**City of Parramatta Council**

File No: DA/1281/2016

**ADDENDUM ASSESSMENT REPORT
Environmental Planning & Assessment Act 1979****SUMMARY**

Addendum to DA No:	DA/1281/2016 (SCCPP Ref: 2017SWC007 – original assessment report dated 6 December 2017 to SCCPP)
Property:	Lot 30 in DP 1106209 and Lots 6, 7, 8 & 9 in DP 22506, 12 Station Road & 4-10 Wentworth Avenue, TOONGABBIE, NSW 2146
Proposal:	Demolition works, amalgamation of lots and re-subdivision for construction of a 128 bed Residential Care Facility (RCF) at the 'Toongabbie Sports Club', provision of vehicular access, landscaping, signage and ancillary stormwater and civil works (Nominated Integrated Development under the Water Management Act 2000). The application will be determined by the Sydney Central City Planning Panel.
Date of receipt:	23 December 2016
Applicant:	Opal Aged Care
Owner:	Toongabbie Sports & Bowling Club Limited
Property owned by a Council employee or Councillor:	The site is not known to be owned by a Council employee or Councillor
Political donations/gifts disclosed:	None disclosed on the application form

Figure 1 – Subject site (red) and proposed development zone and location of the RCF (blue). Source: SEE prepared by BBC Consulting Planners

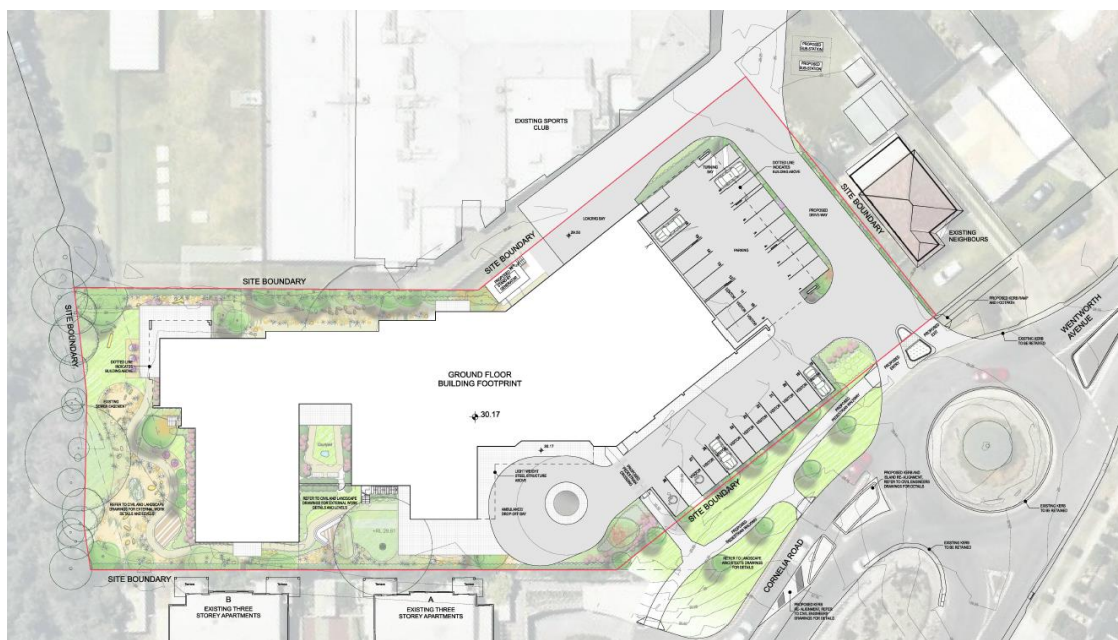
Discussions focussed on the design of the residential care facility (RCF) and the flood events along Girraween Creek. The applicant group advised Council they had not conducted any pre-development, post-development, 100-year flood and larger flood events modelling within the site and across the catchment. The applicant group stated there will be fill between 0.8m to 1.2m above the natural ground level across the development site including the carpark and landscaped areas (see **Figure 1**) which covers approximately 4,887.4m² of flood-prone land resulting in modified ground levels above the flood planning level.

Council does not allow any fill in the floodplain as this creates a loss of flood storage or flood conveyance capacity elsewhere either upstream or downstream.
